Department of Environmental Quality

June 27, 2024

Re: WQ: CAS: Variance Denial: 248-23-000488-VAR: 17089 Indio Rd; T.20S; R.10E; Sec. 12D; Tax Lot 16900; Deschutes River Recreation Homesites Inc. (C), 0.57 Acres; Deschutes County.

**SUBJECT: Formal Variance Request – Pineriver Homes LLC – T20S, R10E, Section 12D,
Tax Lot 16900 (0.49 acres), Deschutes County, South of Bend, Oregon.**

Figure 3. Modified Bottomless Sand Filter Section

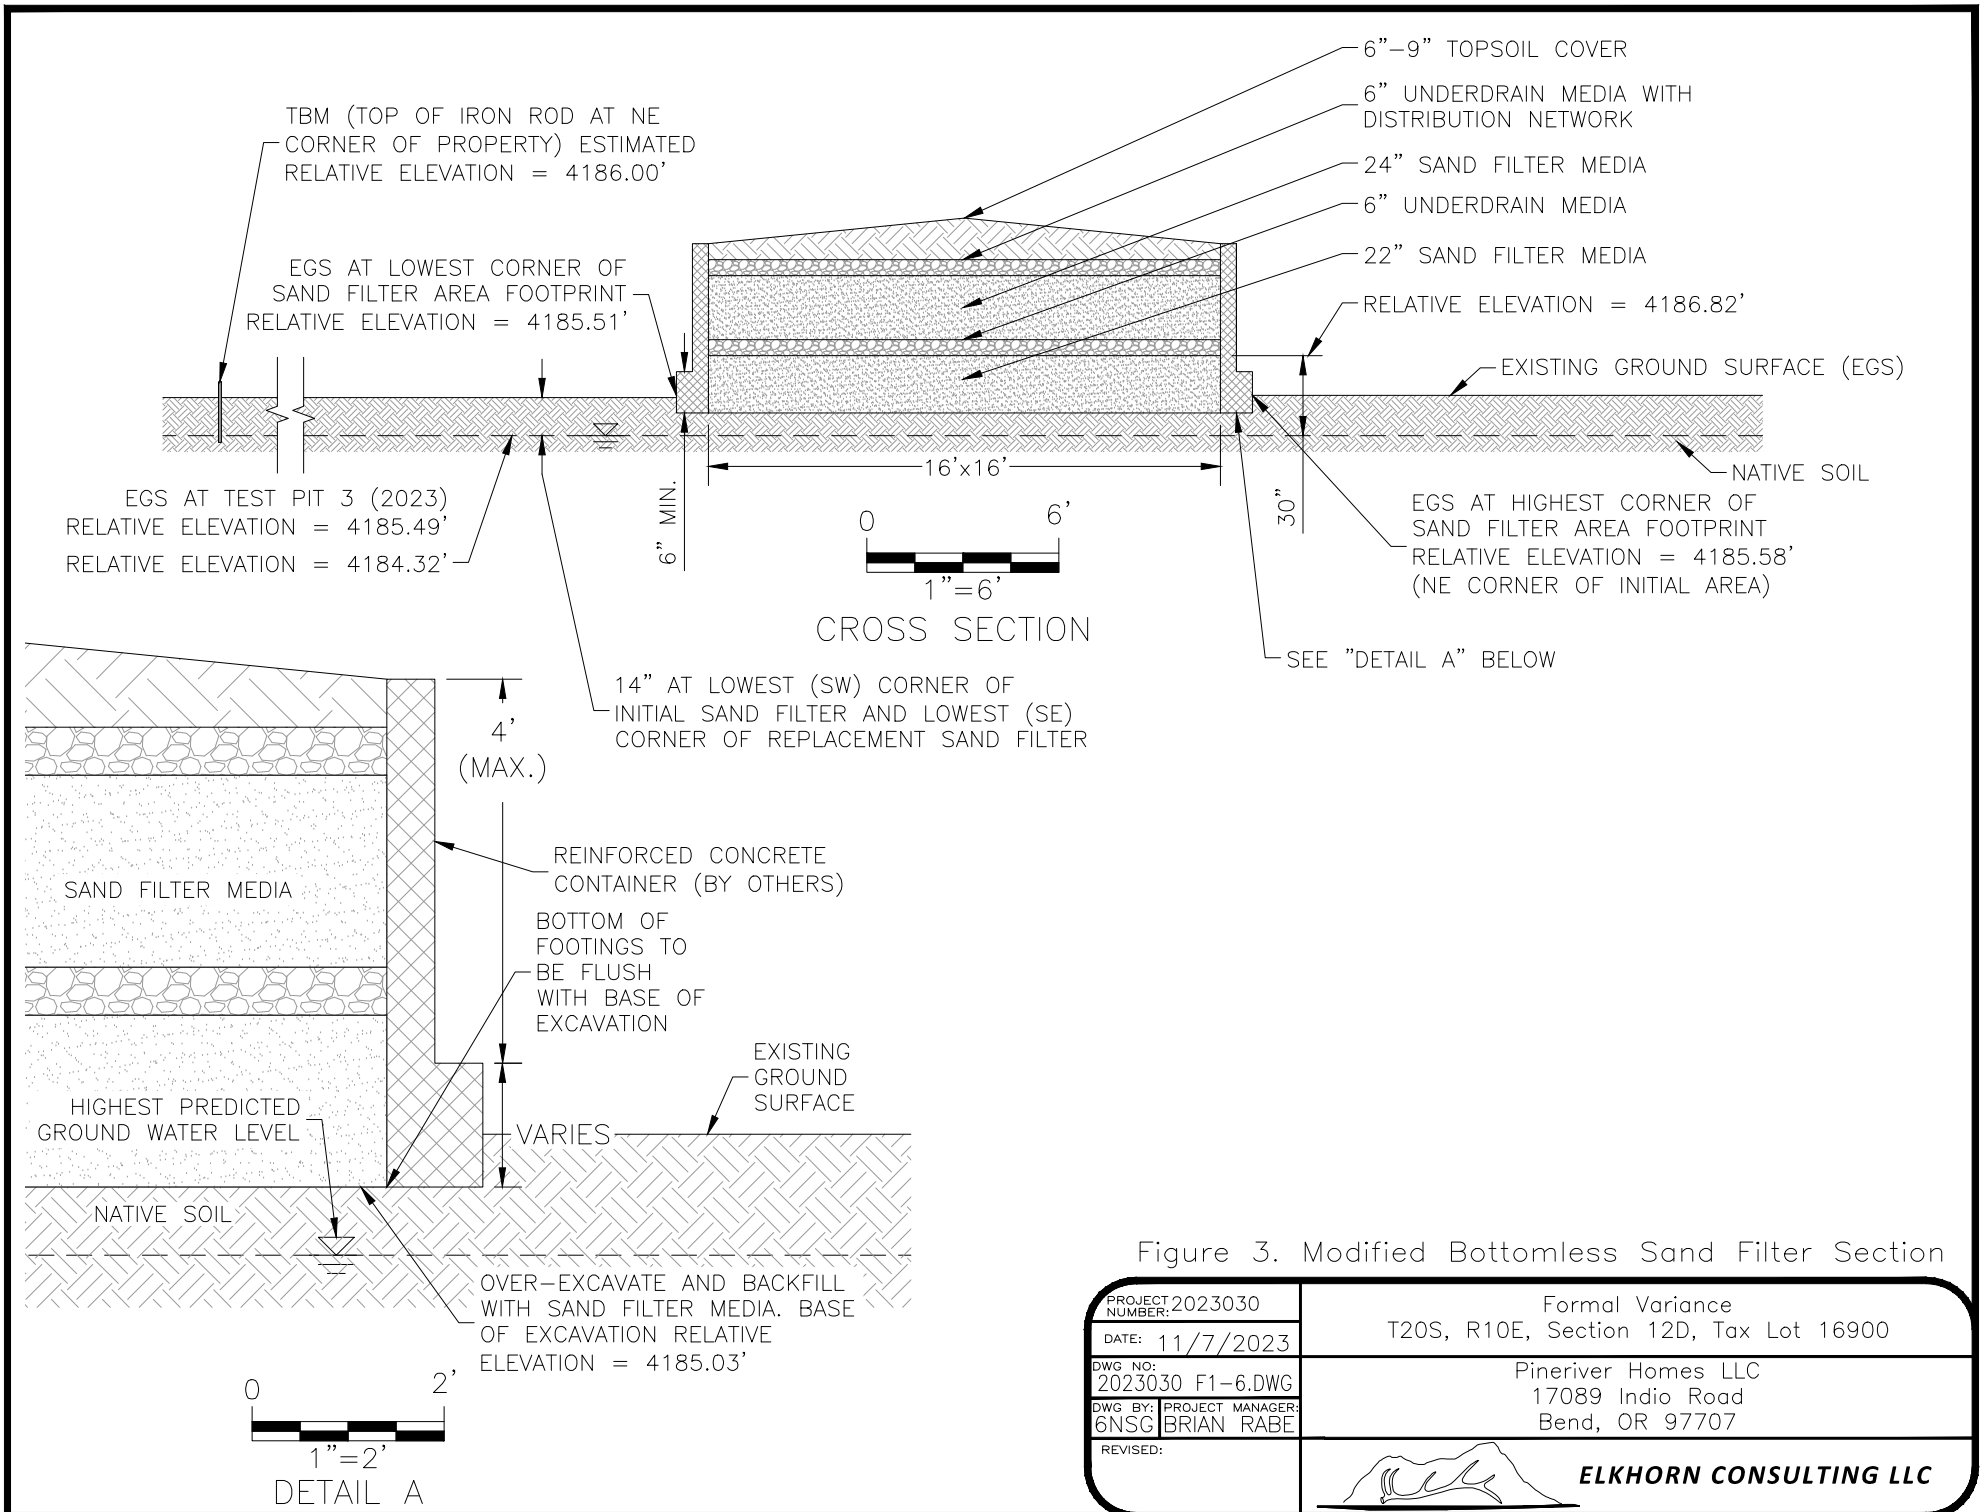
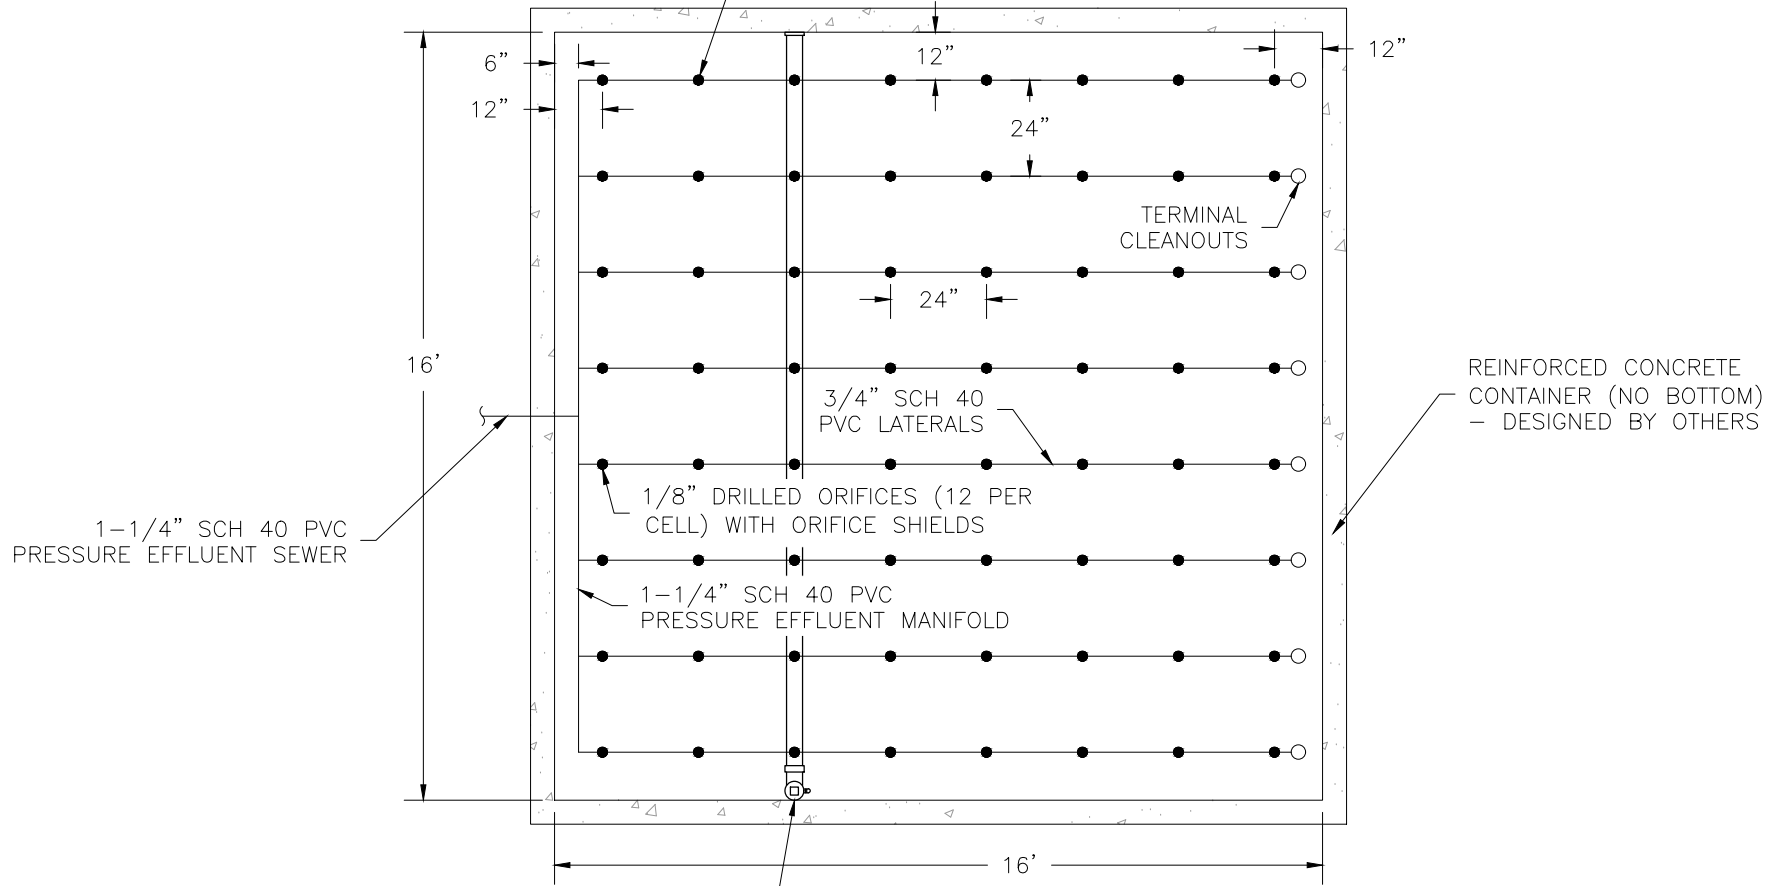
- Current Oregon Administrative Rules require that the water table is at least 24 inches below the ground surface throughout the year, and a minimum 24-inch separation is maintained between a water table and the bottom of the sand filter. The proposal assumes a seasonally high shallow permanent water table of 10 inches below ground surface; however, based on observed soil characteristics from the site evaluation by Deschutes County on September 19, 2023 and during the variance officer's site visit on April 23, 2024, it is likely that saturated conditions occur at even shallower depths within the proposed area.
- Southern Deschutes County is an area where nitrate contamination is of concern due to coarse rapidly draining soils overlaying a shallow unconfined aquifer. Many lots are served

The proposal was to install an Orenco AdvanTex®AX20RTN-Mode 3B Alternative Treatment Technology (ATT) System prior to discharge to RidNox post anoxic tank (solid phase flow through filter) followed by a 250 square foot reduced sized Bottomless Sand Filter (BSF) system constructed on an additional 16 inches of sand filter media to the ground surface. This provides 30 inches of separation between the bottom of the conventional bottomless sand filter design and the highest potential groundwater in this area (assumed at 14 inches bgs for this design).

A site visit was made by the variance officer on April 23, 2024 to observe the site and proposed system layout. The stake-out of the bottomless sand filter locations appeared to match the proposal site plan and were located near the existing test pits 1&2 from the site evaluation conducted by Deschutes County. Gray / depleted soil colors were observed to the ground surface in both pits, indicating that the depth of seasonal high saturation could be higher than the assumed depths used for the proposed system.
